| AVIATION Artur Trendak and Son | SERVICE BULLETIN | 18.07.2016 |
| | | No. 16-01 |

SUBJECT: ENGINE SUPPORT INSPECTION

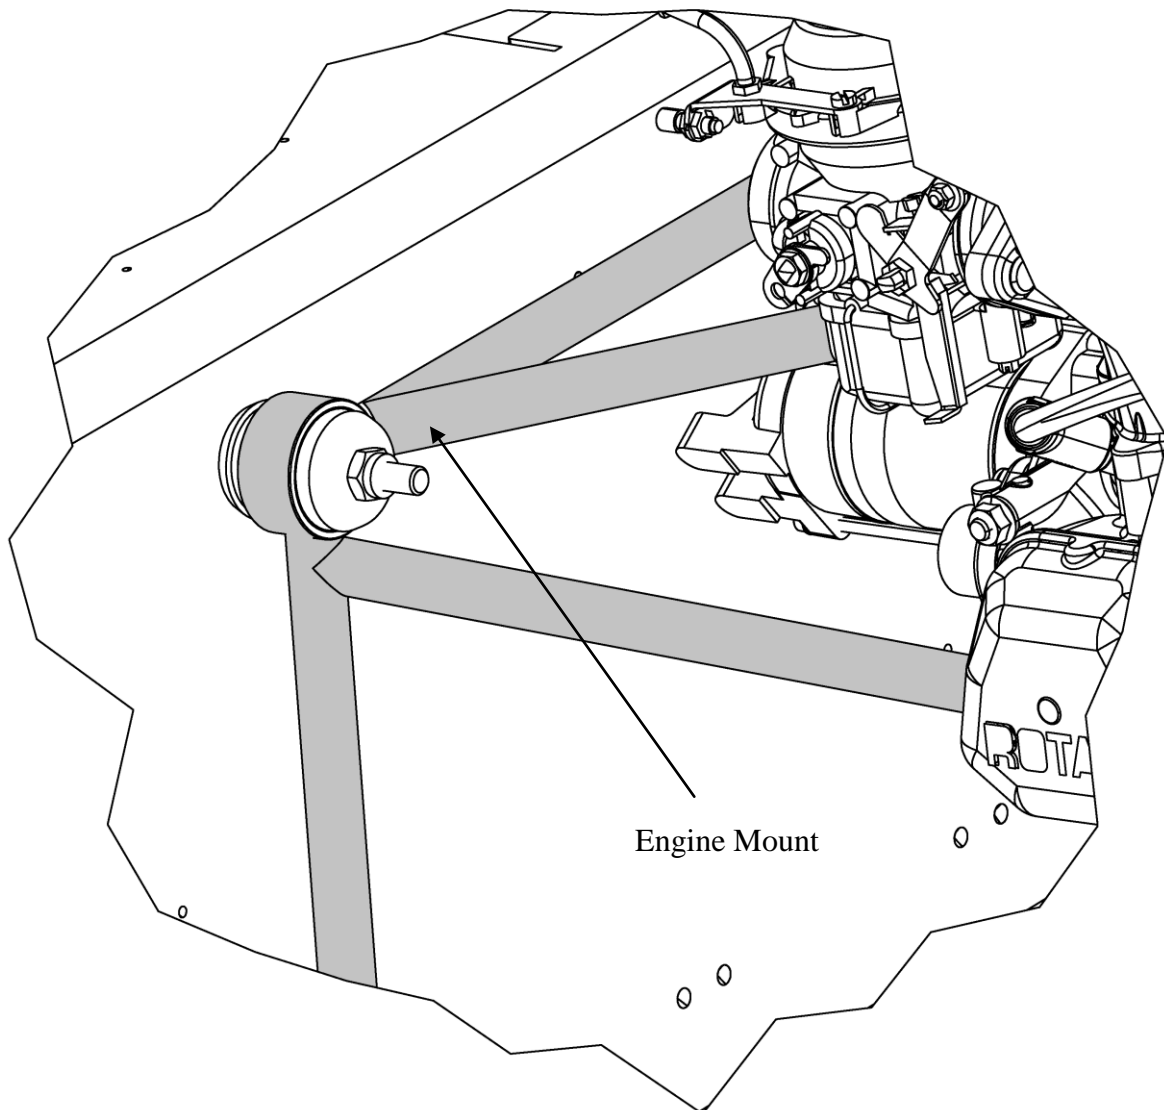
REASON: Inspection of engine support before and after every flight.

1. Before and after every flight inspect Engine Mount for cracks or other deformations. If detected the gyrocopter must be grounded, contact the manufacturer to specify the way to restore airworthiness.
